ADDENDUM NO. 2

VILLAGE OF COVINGTON Wastewater Treatment Plant Improvements Phase II Blower Replacement February 19, 2019

Re: Village of Covington
Wastewater Treatment Plant Improvements Phase II – Blower Replacement

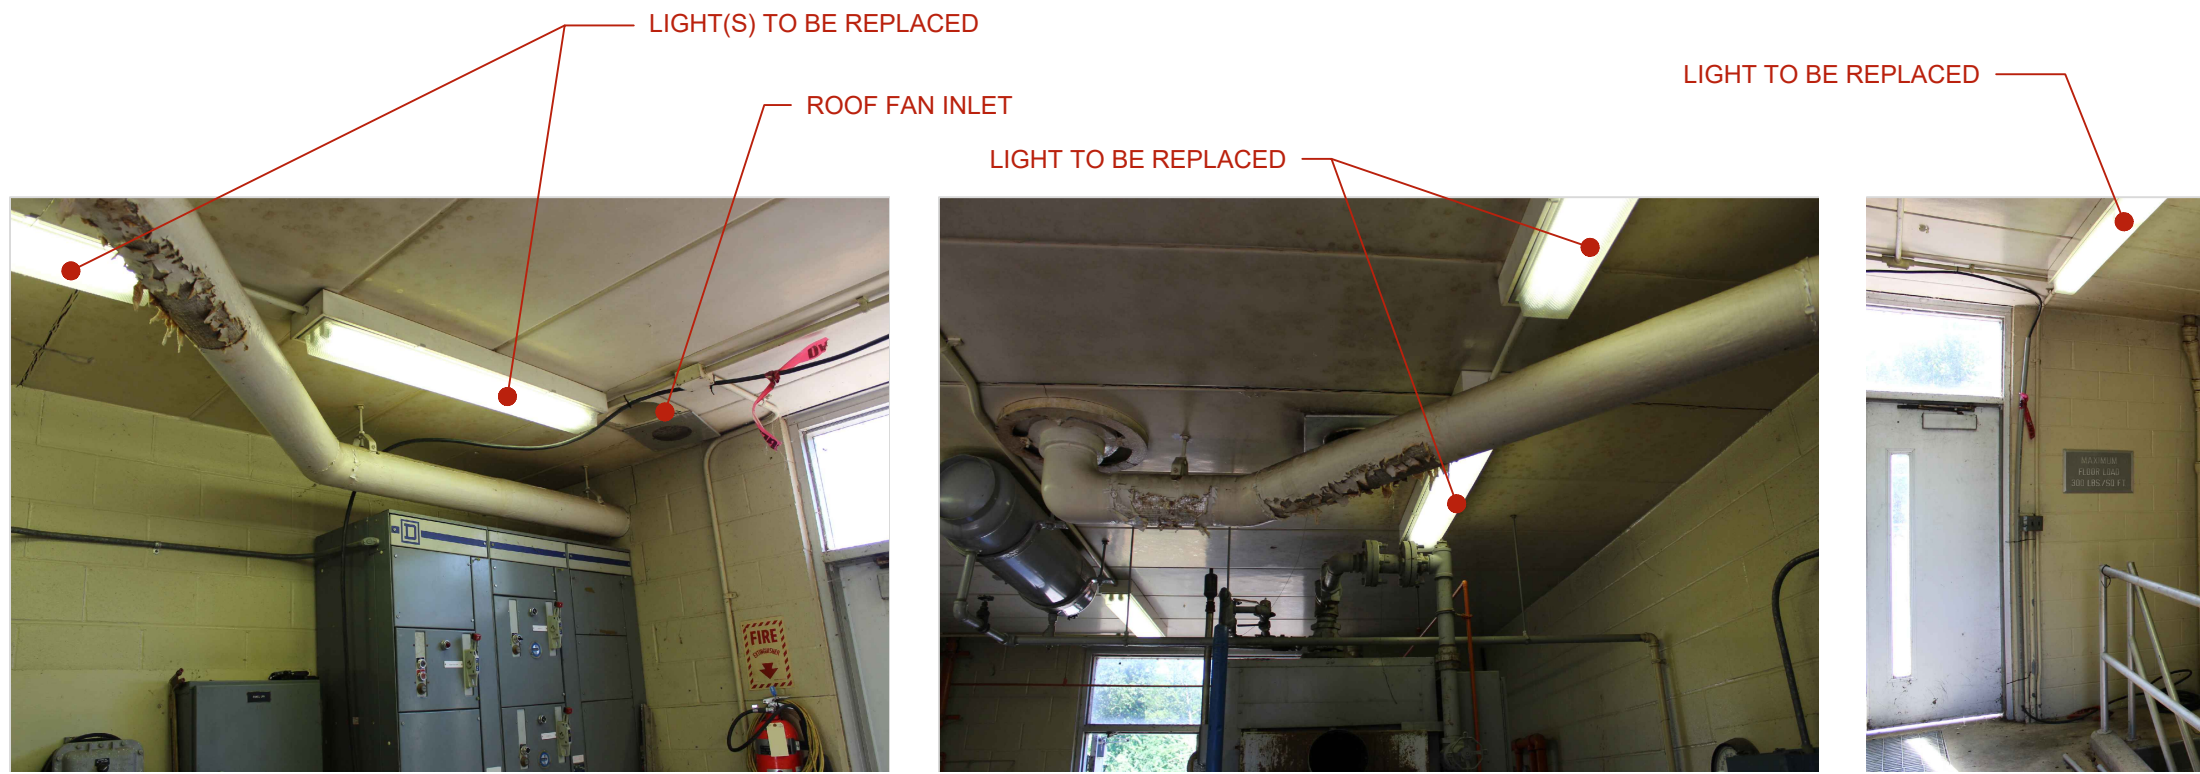
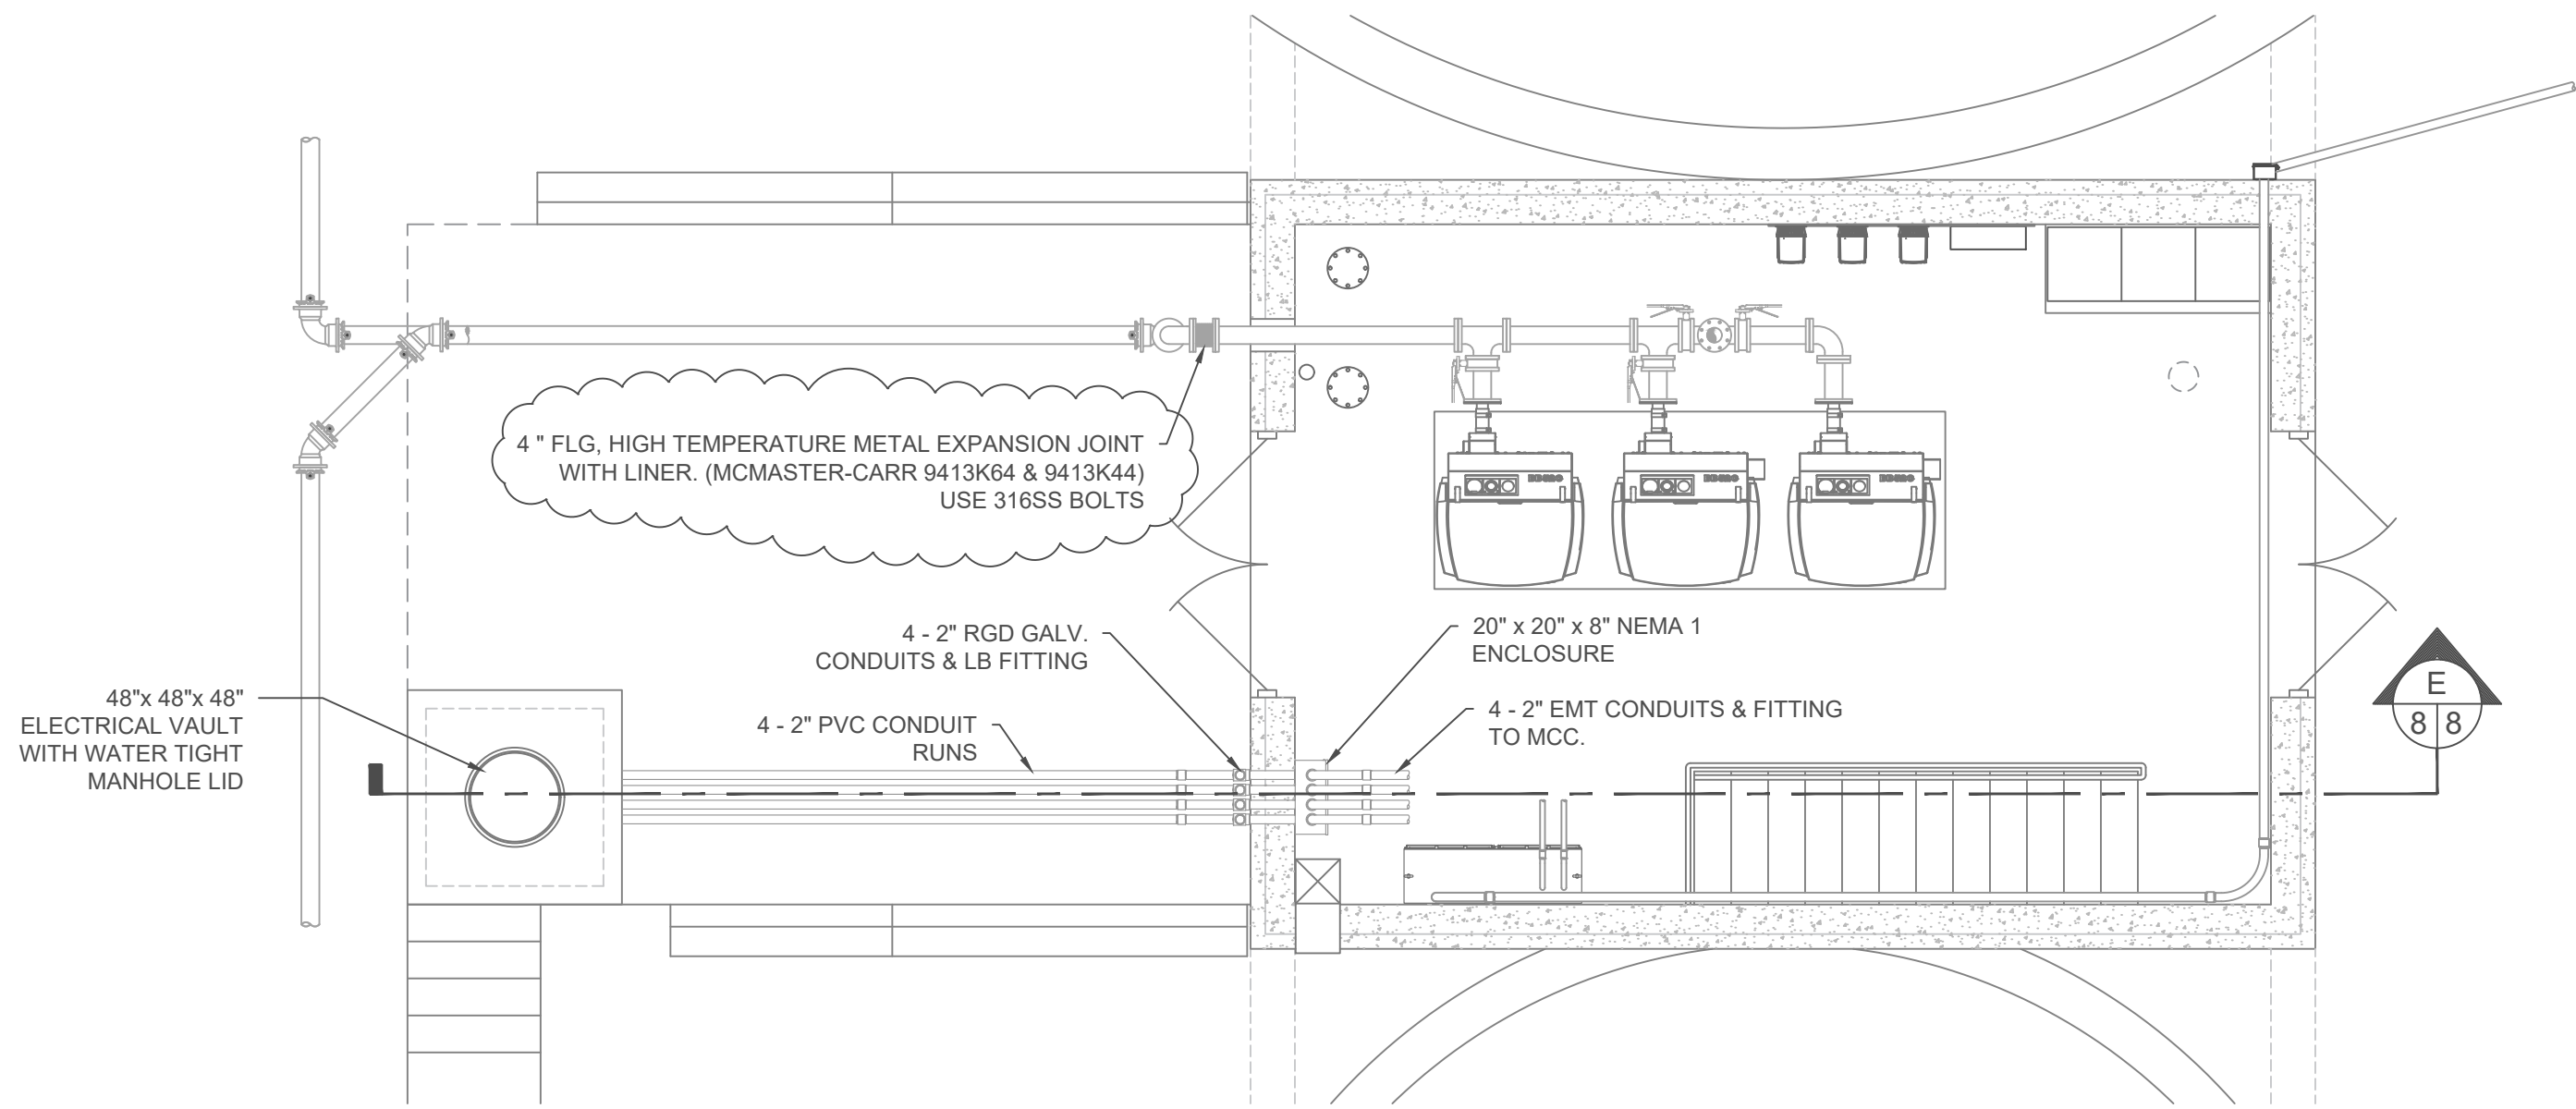
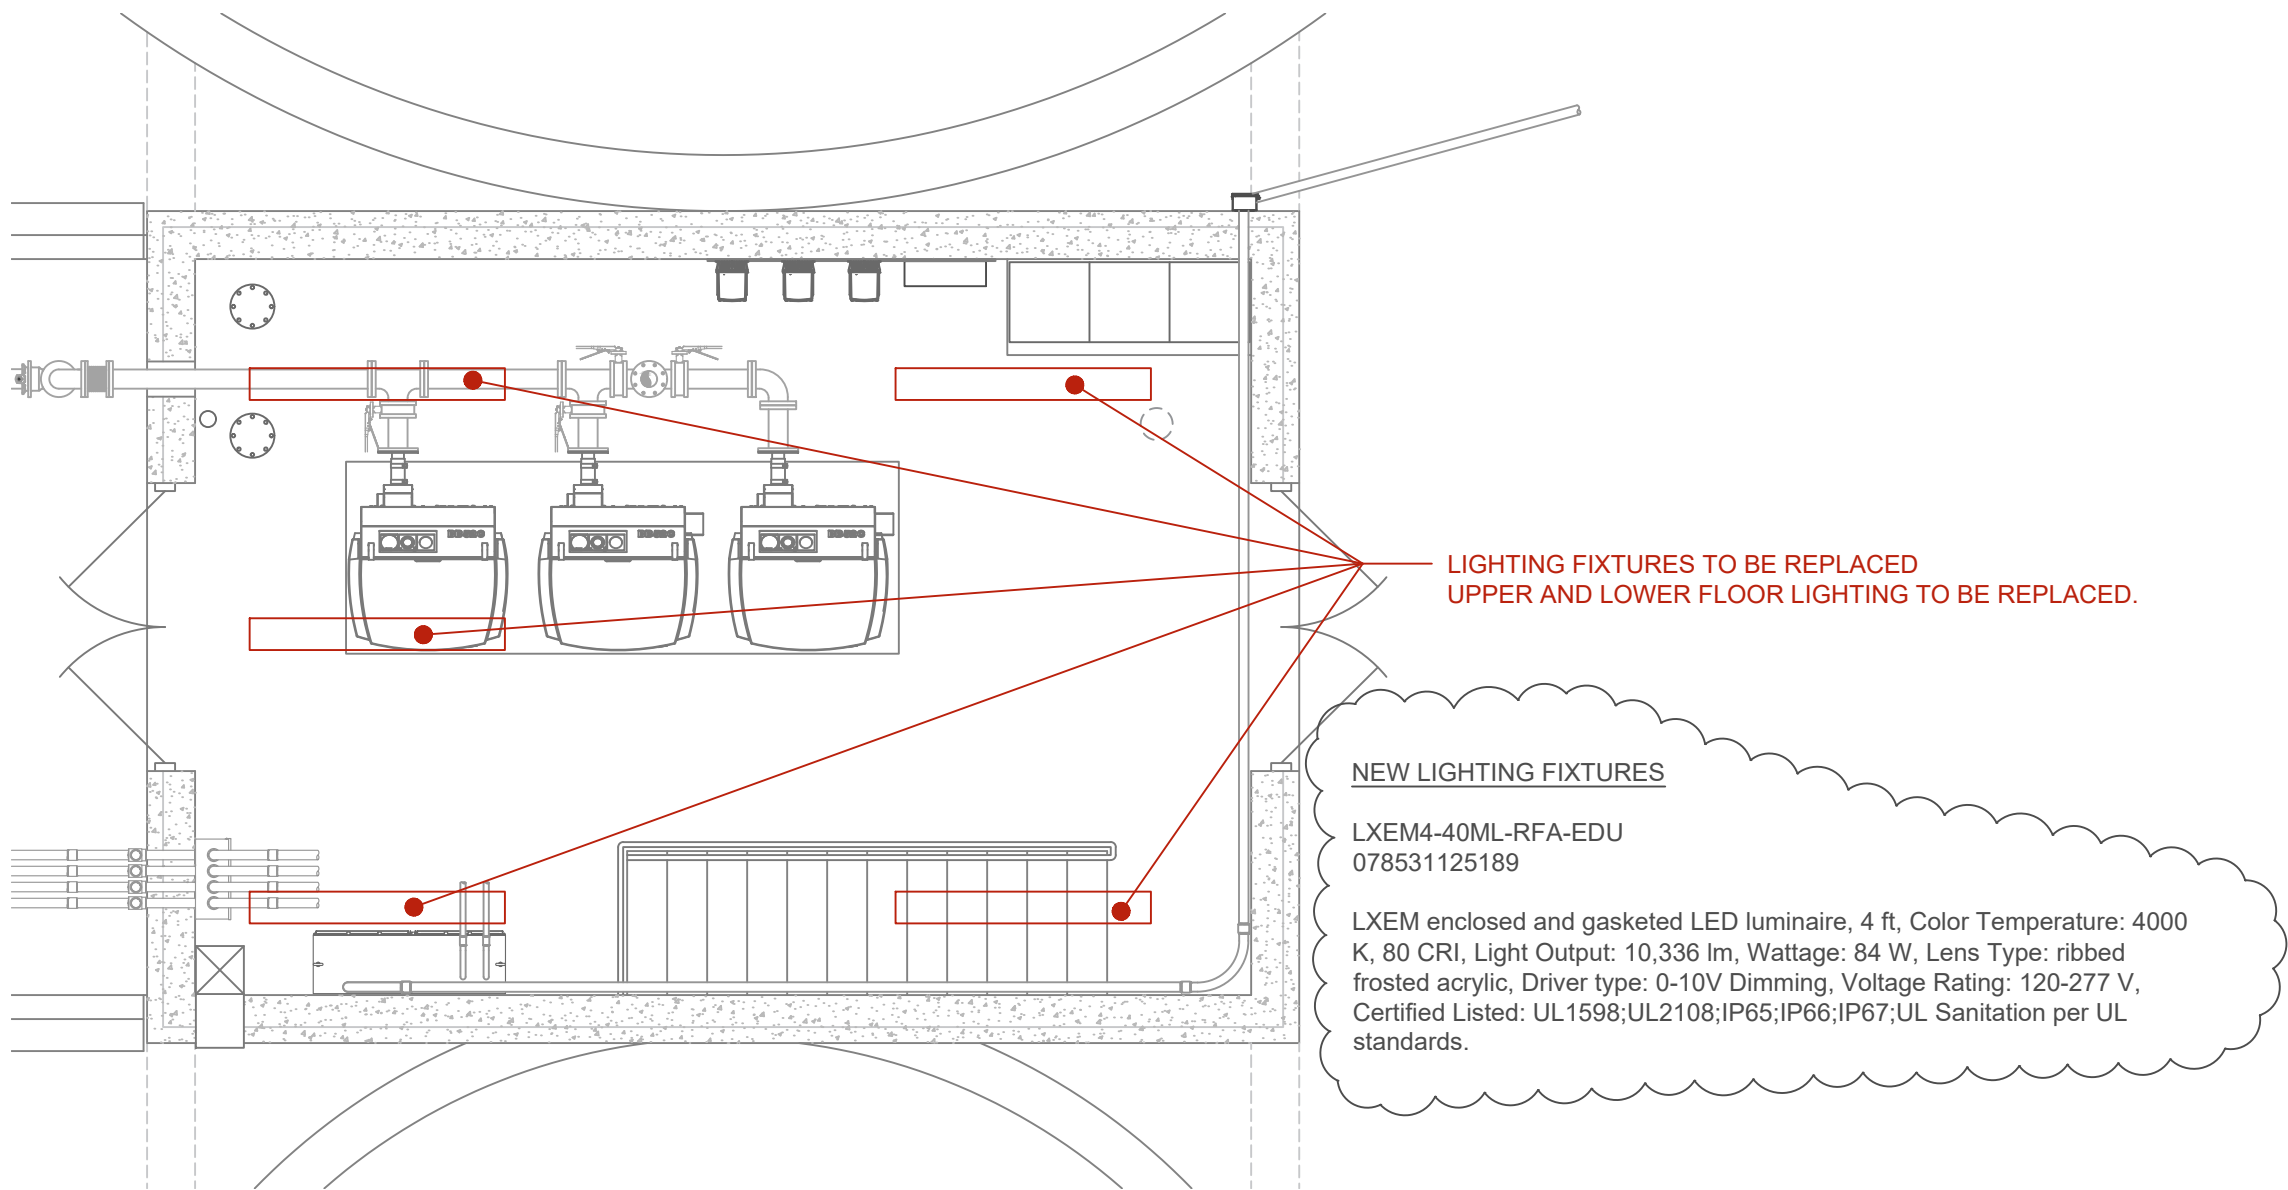
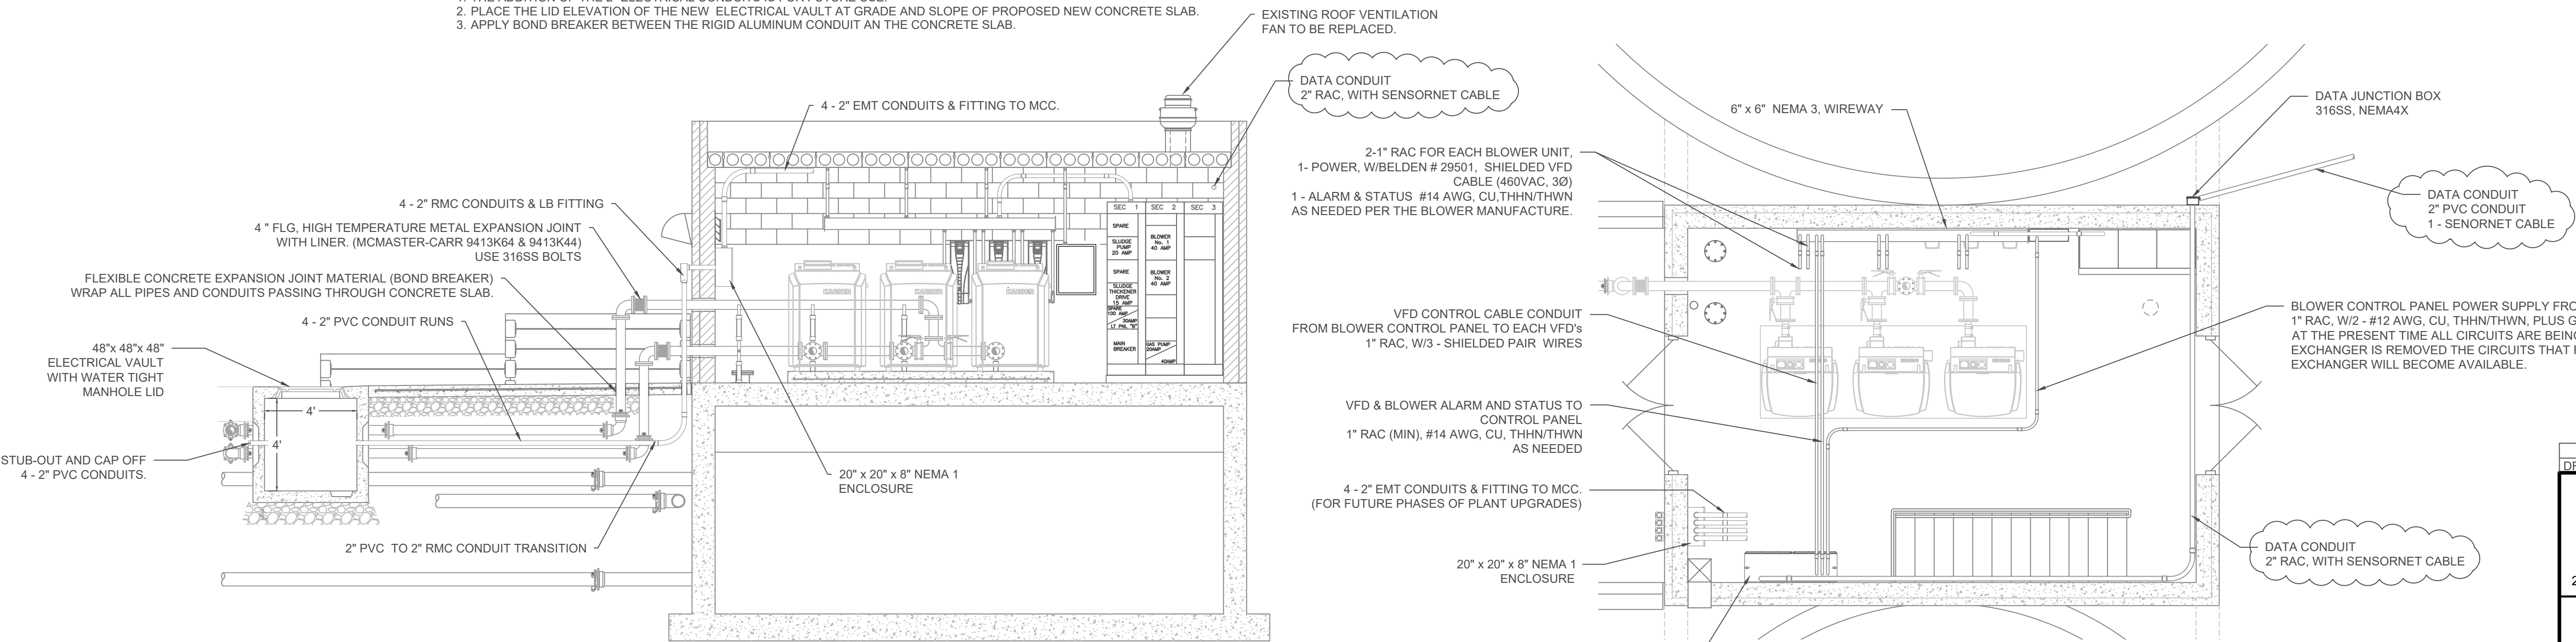
3. Sheet 2A has been updated indicated the amount of air piping to be replaced.
4. Sheets 3A, 4A, 6A, 8A and 9A indicate the changes from fiber-optic to SensorNet Cables.
5. Sheet 5A clarifies the water piping and obsolete equipment to be removed.

REVISIONS:	
DRM	15 FEB 2019 REMOVE FIBER-OPTIC AND REPLACE WITH YSI SENSORNET
 Mote & Associates Engineering, Land Surveying	
214 W. Fourth St., Greenville, OH 45331 937.548.7511 www.moteassociates.com	
ELECTRICAL UPGRADE DETAILS WWTP IMPROVEMENTS PHASE 2 VILLAGE OF COVINGTON	
PROJ. NO: CV07112617	DWG. NO: 1D15074
SCALE: AS NOTED	
DRAWN: DRM	CHECKED: MJB
DATE: 02/18/19	SHEET NO: 8A OF 9
